INTERNAL CORRESPONDENCE

SUBJECT: ECO Matrix and rework for IPB, IOC, DRR Boards REV 3

This document contains the rework required to up-grade the IOC, IPB, DRR Channel and interface boards to the latest correct dash and REV level.

FIGURE 2

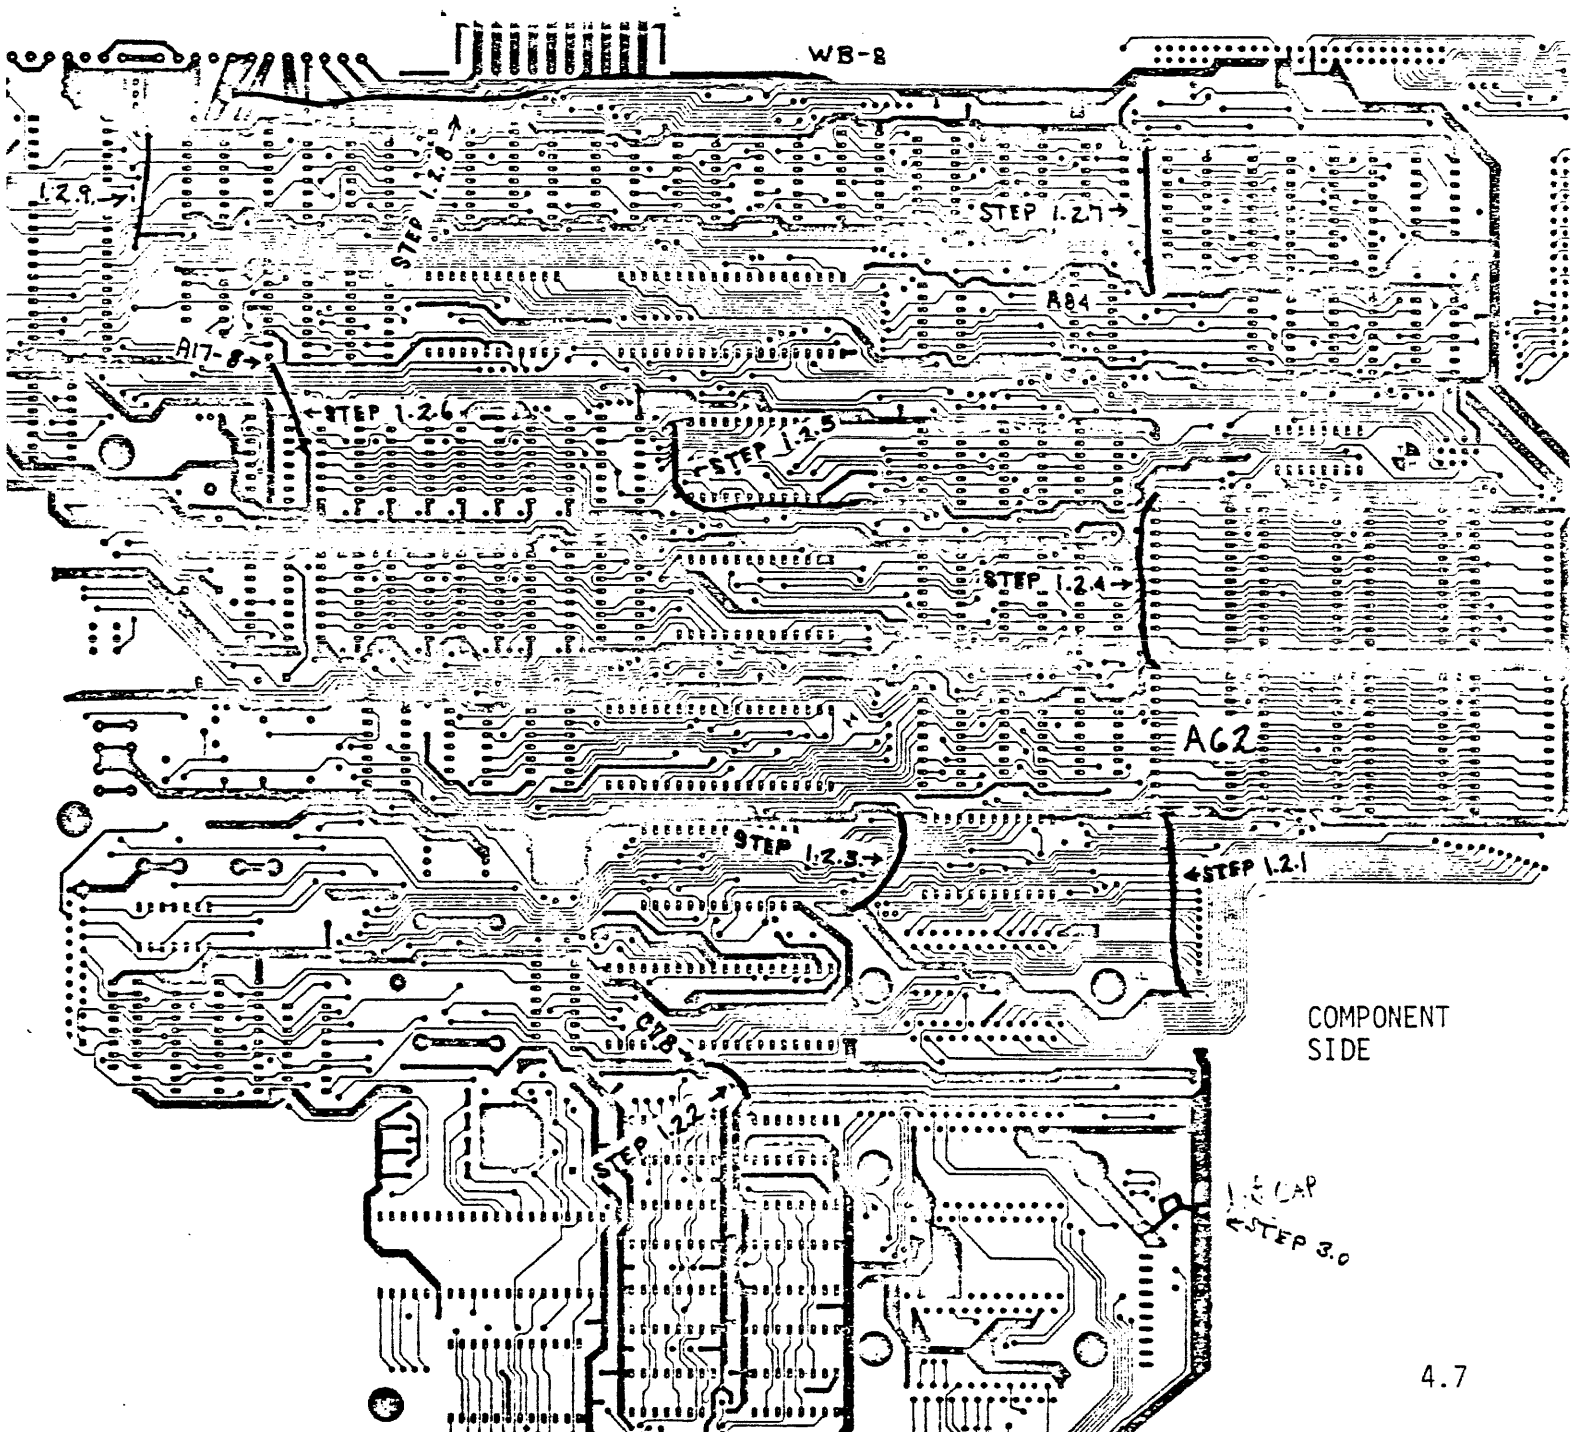
1.2 Component Side

1.2.3 From double feedthru on gnd bus beside A66-28 to A67-12

FIGURE 3

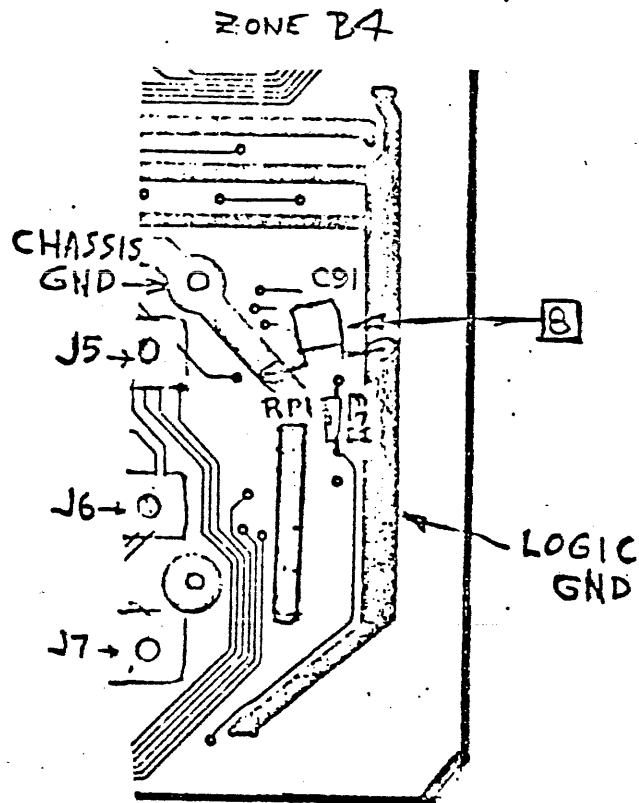
- 1.2.4 From bus at lead of R37 to double feedthru near A50-1.
 - 1.2.5 From bus running under body of R26 at C24 lead to bus connecting C23 and A35-12.
 - 1.2.6 From bus at lead of C19 (going to C28) to A17-8.
 - 1.2.7 From gnd bus between A84-16 and C16 to heavy gnd bus at C8.
 - 1.2.8 From gnd bus at W8-B to double feedthru beside R6 single pad (bus running to J16 - 5 & 6).
 - 1.2.9 From bus between R10 & R11 to gnd plane at R6.
- 3.0 Solder $1\mu\text{F}$ capacitor 101754-061 from chassis gnd to logic gnd by R53.
(SEE FIGURE 3)

ECO 1805

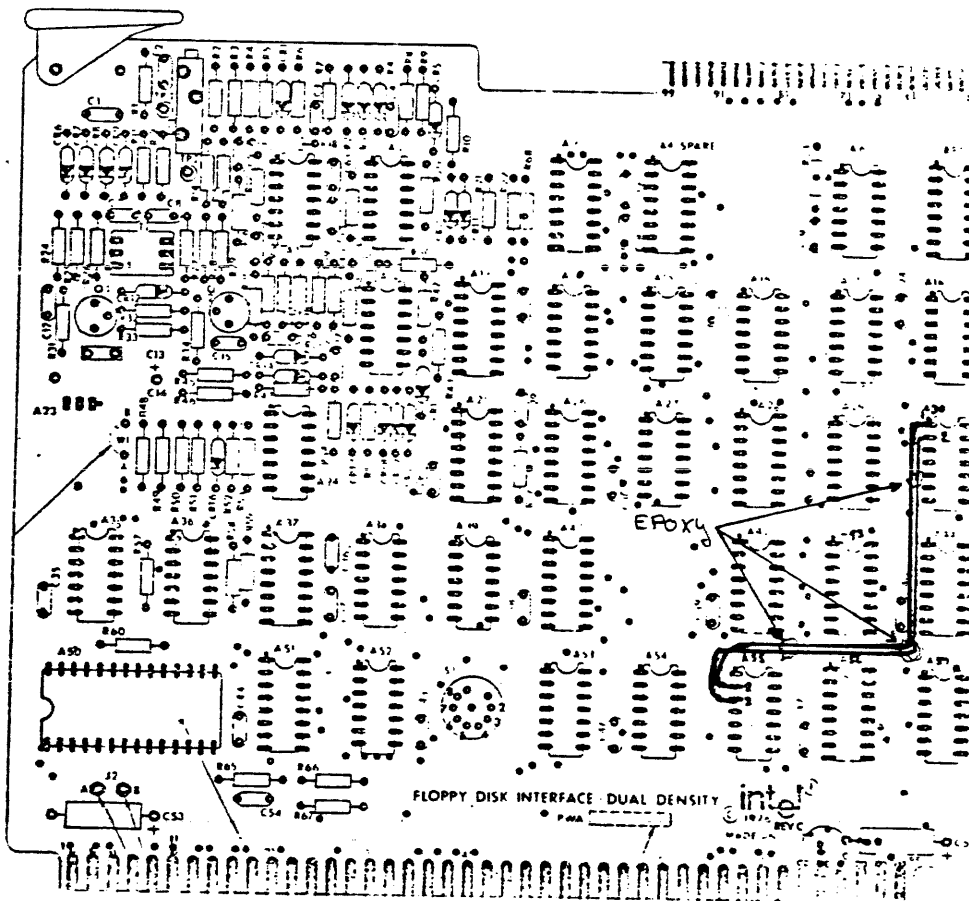
1. Remove Pin 3 A55 from the board and cut the pin off as close to the body of the IC as possible.
2. Add a wire from A30 Pin 1 to A55 Pin 2 using 22 gauge wire.
3. Add a wire from A30 Pin 2 to the pad where A55 Pin 3 was formerly located.
4. Epoxy at point shown in figure below:

ECO 3841

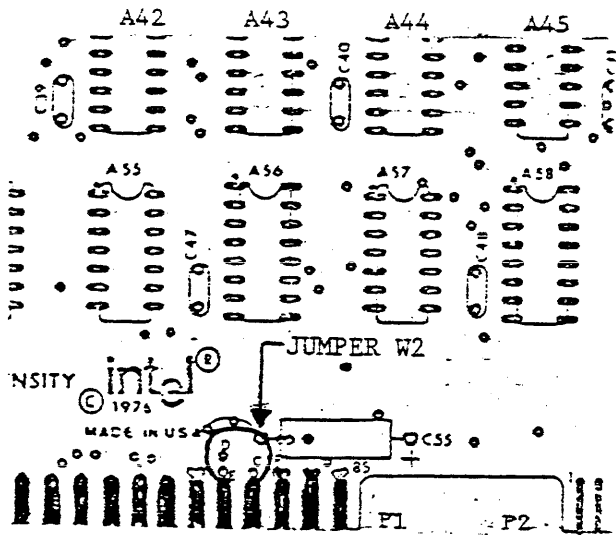
1. Location of jumper W2 must be changed from D to C and changed to D to E, to utilize -10V power supply in Series II.

Fig. 1

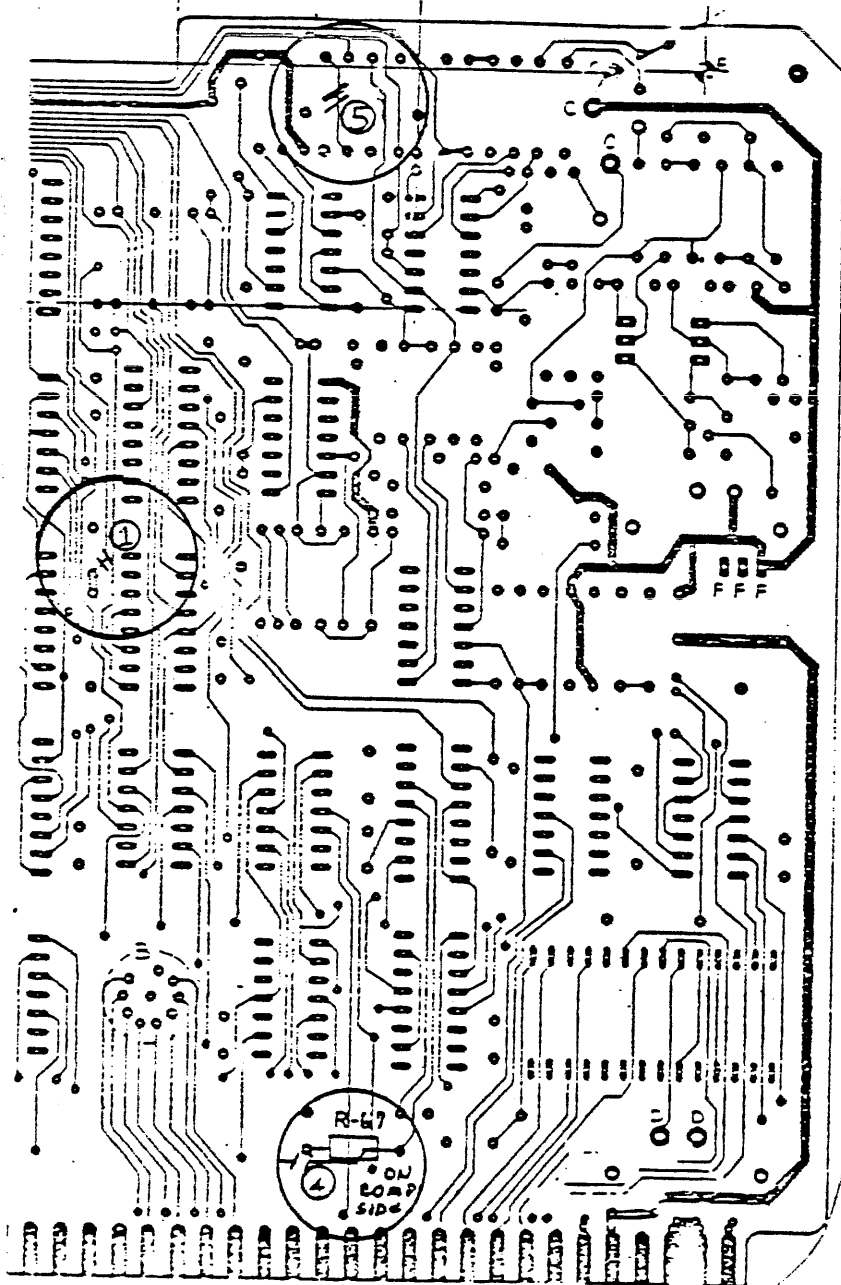
*CUT NO.	FROM	TO	BOARD SIDE
1.	J1-85	A25-14	Solder
2.	J1-70	A61-14	Solder
3.	J1-72	A61-2	Solder
4.	P2-7	A37-14	Component
5.	CR-3	CR-4	Solder

Fig. 3

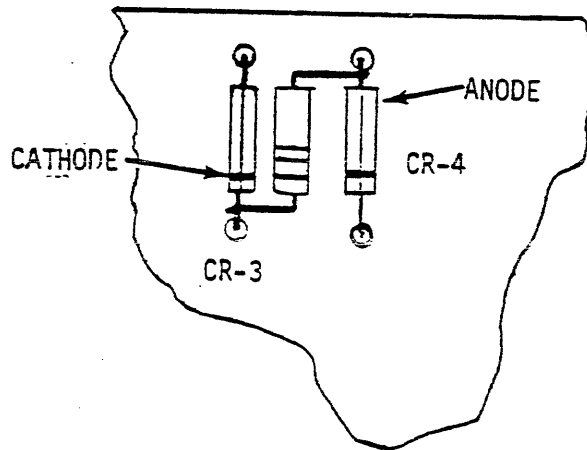
2.) Add the following using Fig. 3:

Add the 15 ohm $\frac{1}{4}$ watt resistor from the cathode of CR-3 to the anode of CR-4 on the component side of the board.

ECO 1630 - PWA 1001241-04 REV. 12 TO REV. 13, USING PWB 1001242-04 REV 8.

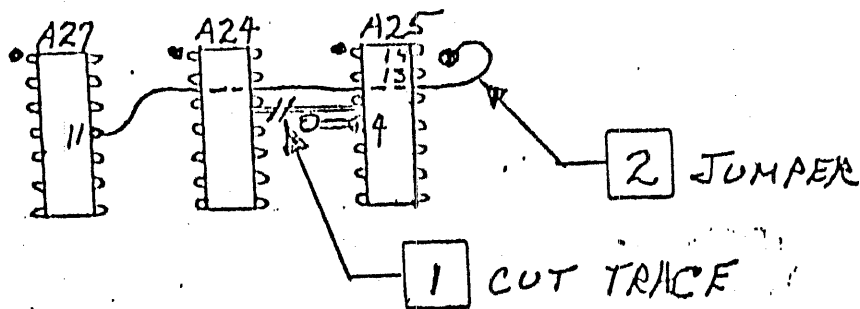
- STEP **1** CUT TRACE ABOVE FEEDTHRU BESIDE A25-4 (COMPONENT SIDE).
- STEP **2**, ADD JUMPER FROM A27-11 TO FEEDTHRU BESIDE A25-13 (COMP. SIDE),
RUNNING WIRE UNDER A24 & A25.

- STEP **3** MARK ECO 1630 ON SOLDER SIDE OF BOARD.

699A (CONT'D) PW13 1001242-04 REV. 8 & 11 ONLY

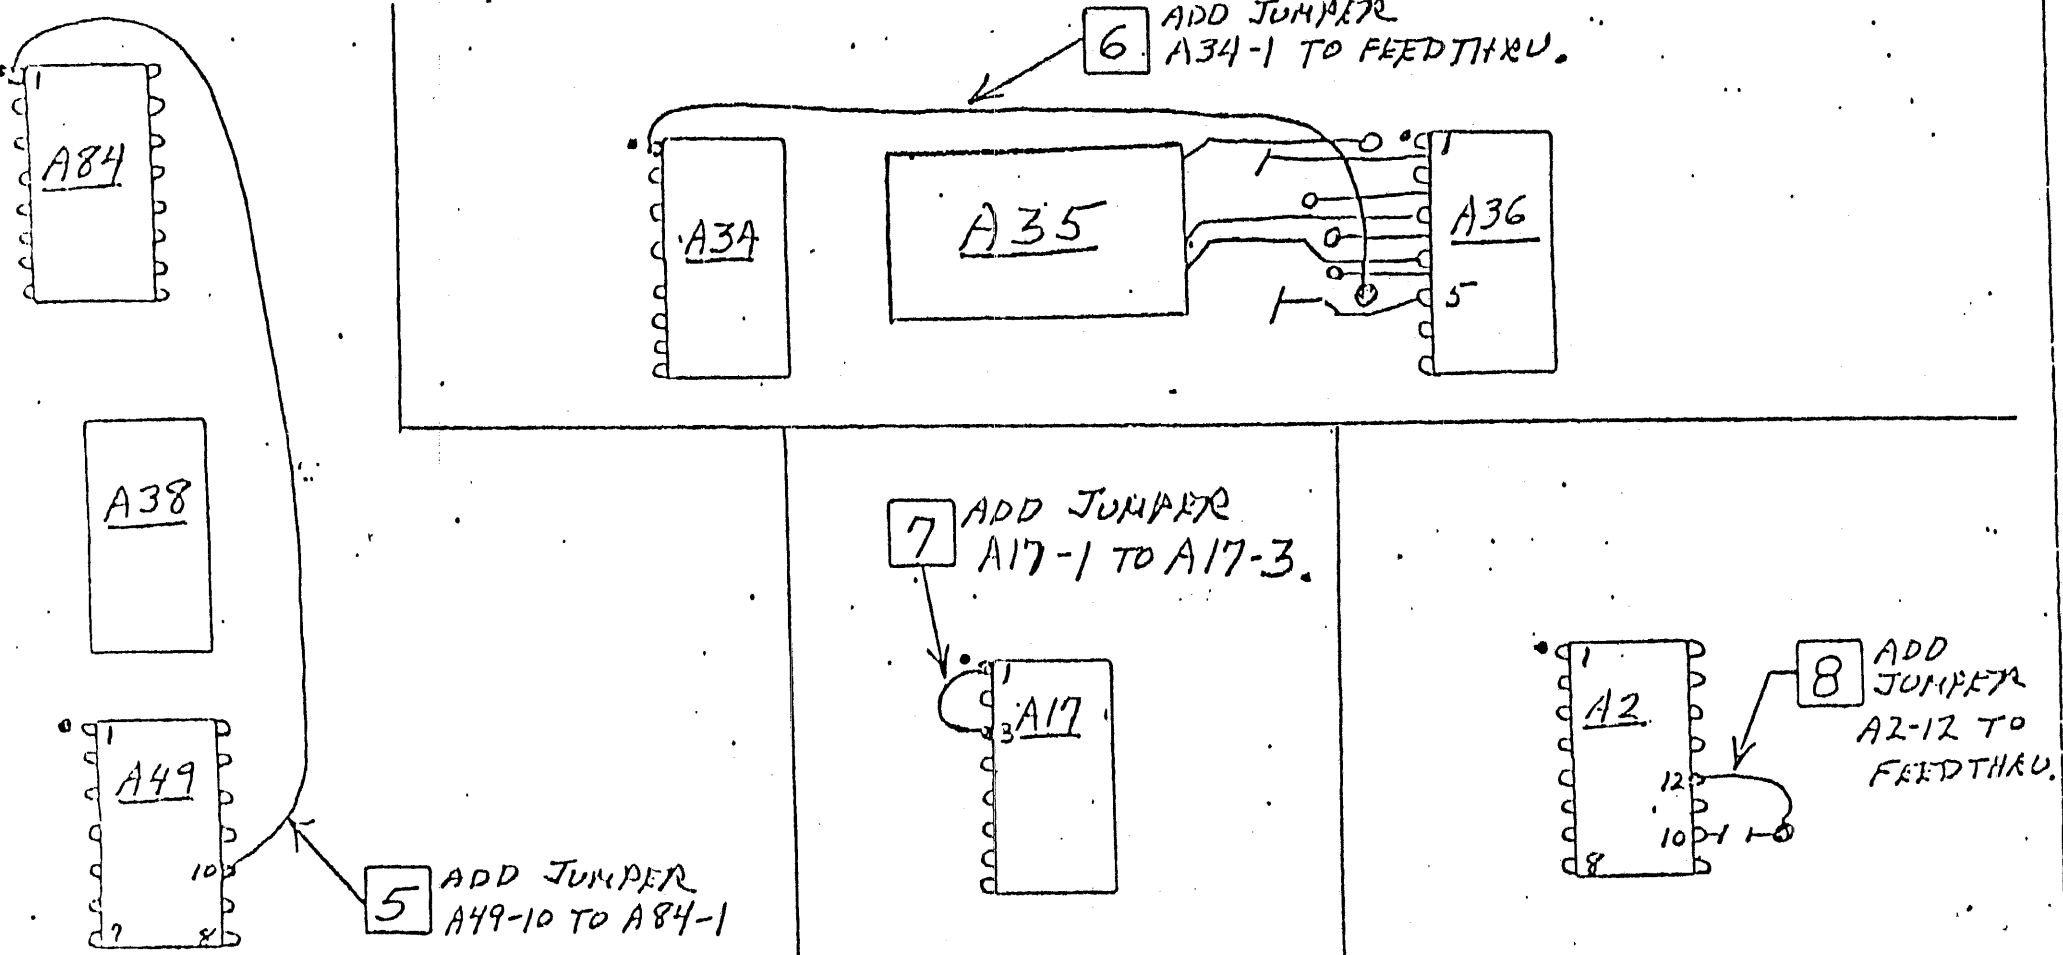
- STEP 5 ADD JUMPER FROM A49-10 TO A84-1. (COMPONENT SIDE).
- STEP 6 ADD JUMPER FROM A34-1 TO FEED THRU ADJACENT TO A36-5 (COMP. SIDE).
- STEP 7 ADD JUMPER FROM A17-1 TO A17-3 (COMPONENT SIDE).
- STEP 8 ADD JUMPER FROM FEEDTHRU ADJACENT TO A2-10 TO A2-12 (COMP. SIDE).
- STEP 9 ADD JUMPER FROM A6-11 TO J18-16 (SOLDER SIDE).
- STEP 10 ADD JUMPER FROM A6-12 & 13 TO A1-39 (SOLDER SIDE).

2699A (CONT'D) PWB 1001242-04 REV. 8 & 11 ONLY.

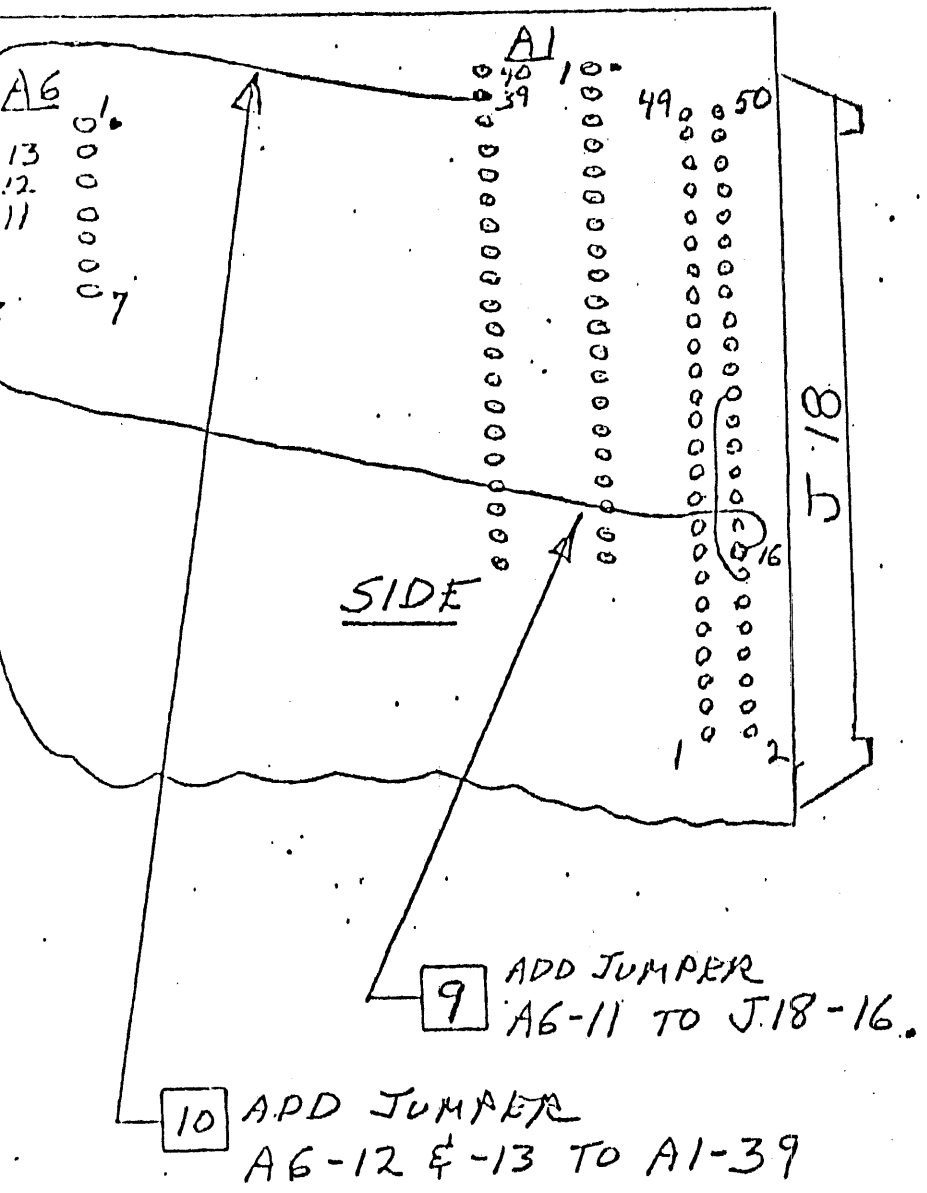
STEP 11 ADD (1EA) 470 Ω RESISTOR
P/N 56-019 FROM A68-6 TO
A68-16 (COMPONENT SIDE).

11 ADD 470 OHM RESISTOR
(56-019) A68-6 TO A68-16

ECO 2699 A (CONT'D) NOTE: FOR 1001242-04 REV. 8, 11, 12 & 13.

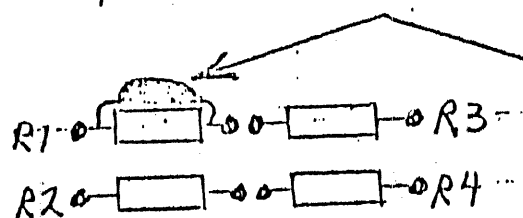
STEP 12 ADD CAPACITOR C-90 IN PARALLEL TO RESISTOR R1.
P/N. 64-007 CAP. CER, .01UF $\pm 20\%$ 25V.

12 ADD CAPACITOR IN.
PARALLEL TO R1

ECO 1630 - PWA 1001241-04 REV. 12 TO REV. 13, USING PWB 1001242-04 REV 8.

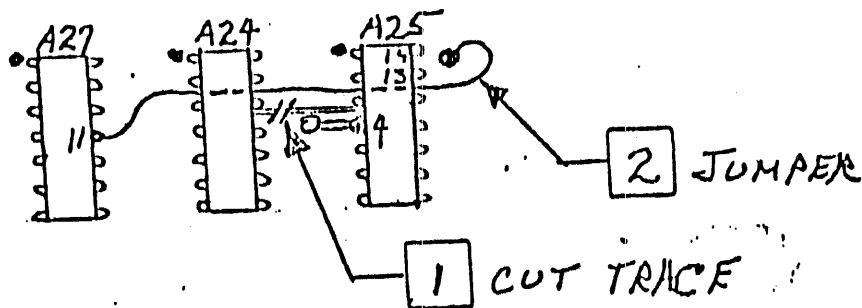
- STEP 1 CUT TRACE ABOVE FEEDTHRU BESIDE A25-4 (COMPONENT SIDE).
- STEP 2 ADD JUMPER FROM A27-11 TO FEEDTHRU BESIDE A25-13 (COMP. SIDE),
RUNNING WIRE UNDER A24 & A25.

- STEP 3 MARK ECO 1630 ON SOLDER SIDE OF BOARD.
